10.0 Supporting Documentation

10.1 Review Comments and Responses

**VA CBOC Prototype
Preliminary Submittal Review Comments**

Prototypes for Standardized Design and Construction Community- Based Outpatient Clinics

Defining Characteristics: One PACT Module

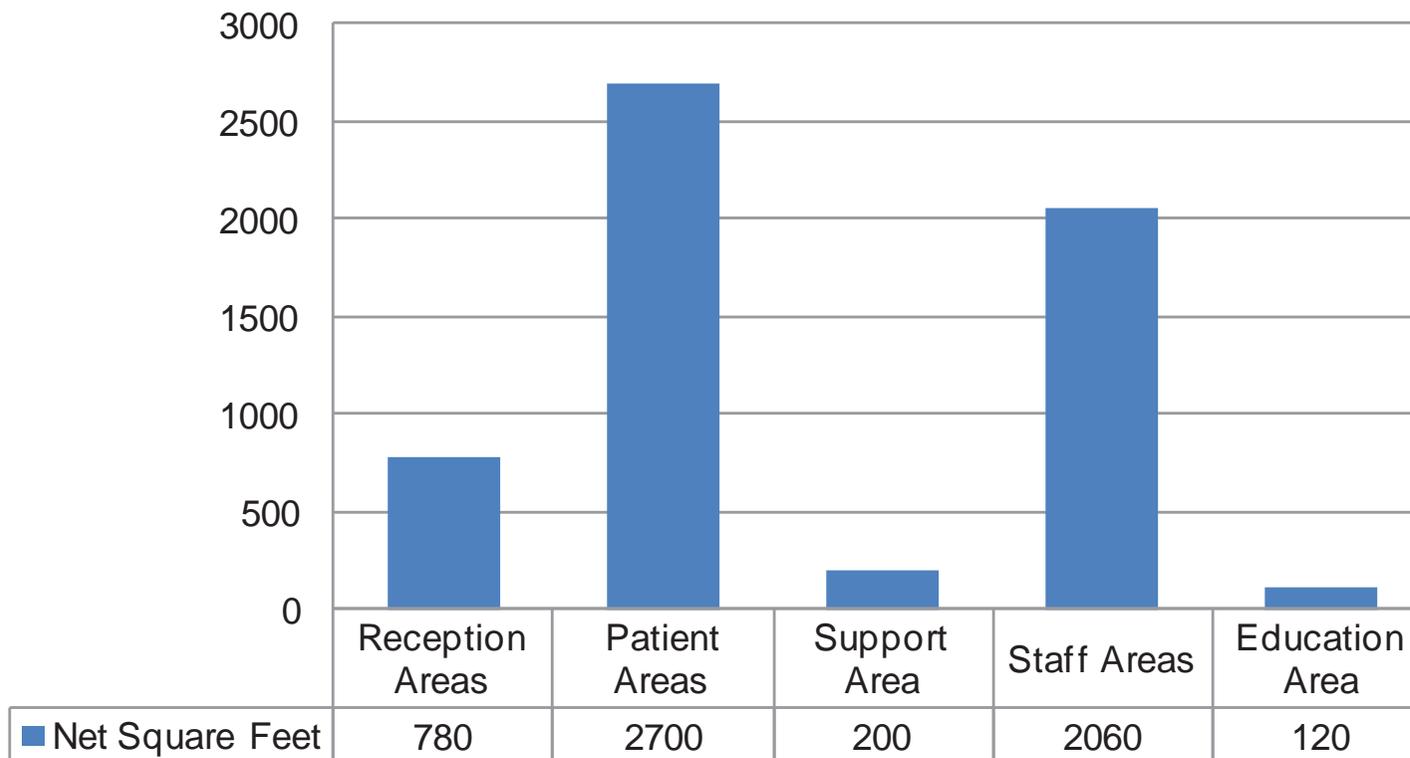
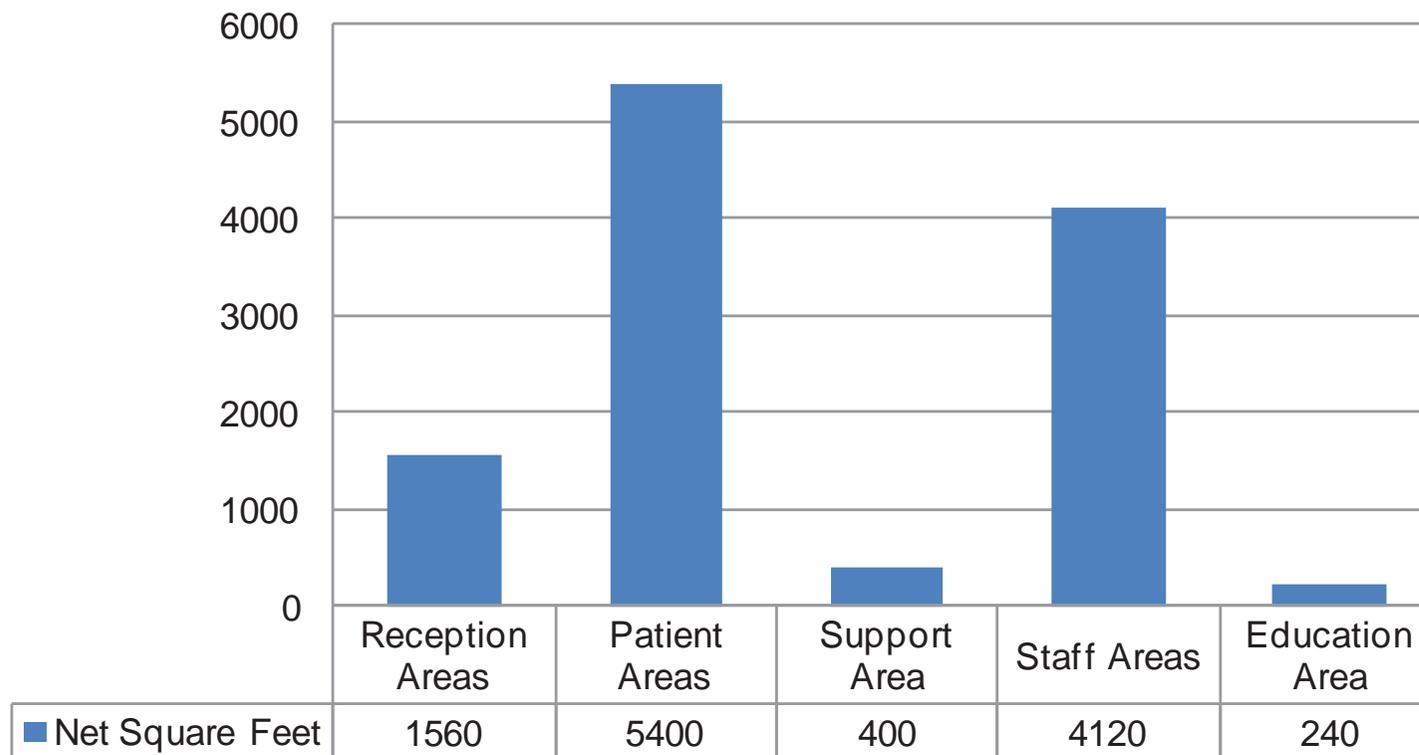
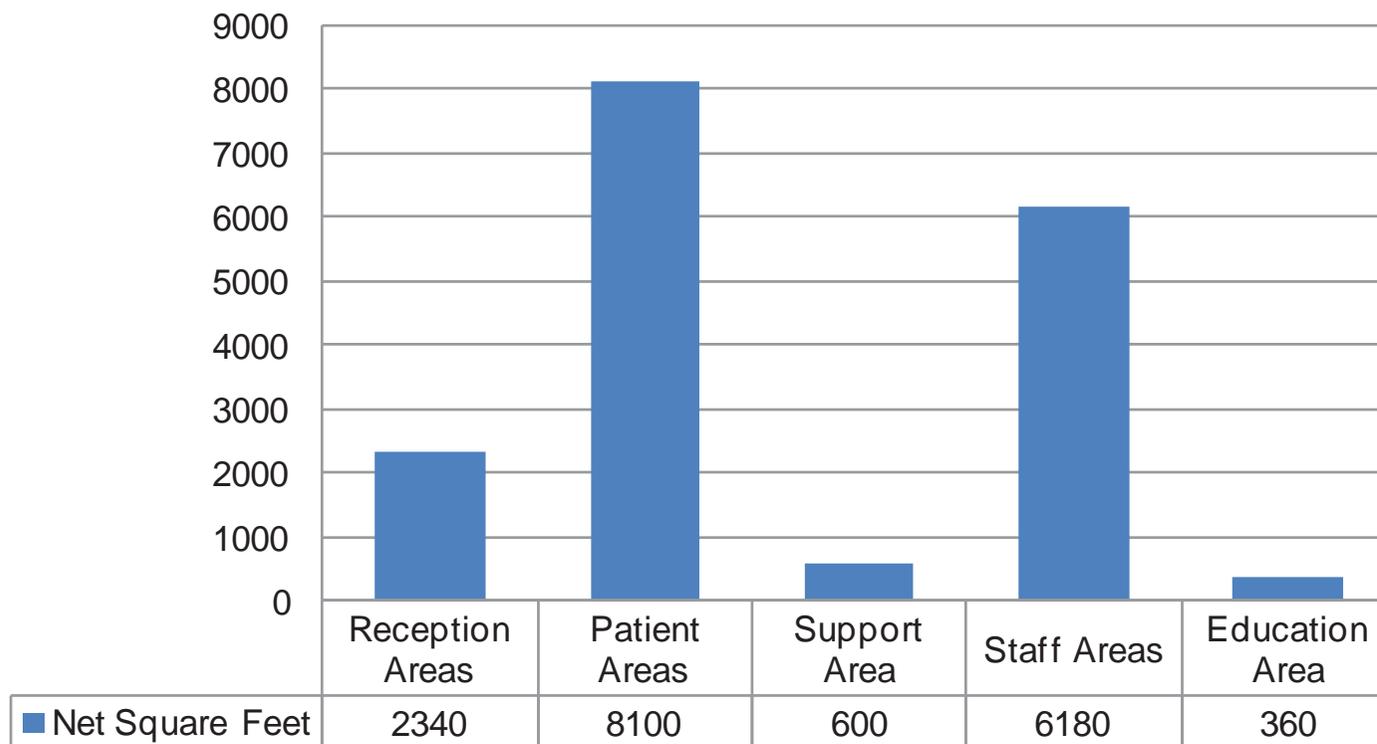
11	Section 2	Am I missing something? Figures 2.3 (One PACT), 2.4 (Two PACT), and 2.5 (Three PACT) are all the same. Why not show one illustration of Defining Characteristics?	This is an error that will be corrected in the Progress Submittal.	Nancy Zivitz Sussman	Office of Construction & Facilities Management (CFM)
12	Section 2	Figure 2.3, 2.4 and 2.5--Net SF Space Allocation by Functional Area is same SF in all three versions--One PACT Module, Two PACT Module and Three PACT Module.	This is an error that will be corrected in the Progress Submittal.	Ved Gupta	Office of Construction & Facilities Management (CFM)
13	Section 2 Page 8	are the two and three pact module space diagrams correct. Seems like they should show different spaces...	This is an error that will be corrected in the Progress Submittal.	Tim Bertuccio	VISN 21 Deputy Capital Asset Manager
14	Section 3	large CBOC - typo 14,400 users not 14,200.	This is an error that will be corrected in the Progress Submittal.	Nancy Zivitz Sussman	Office of Construction & Facilities Management (CFM)
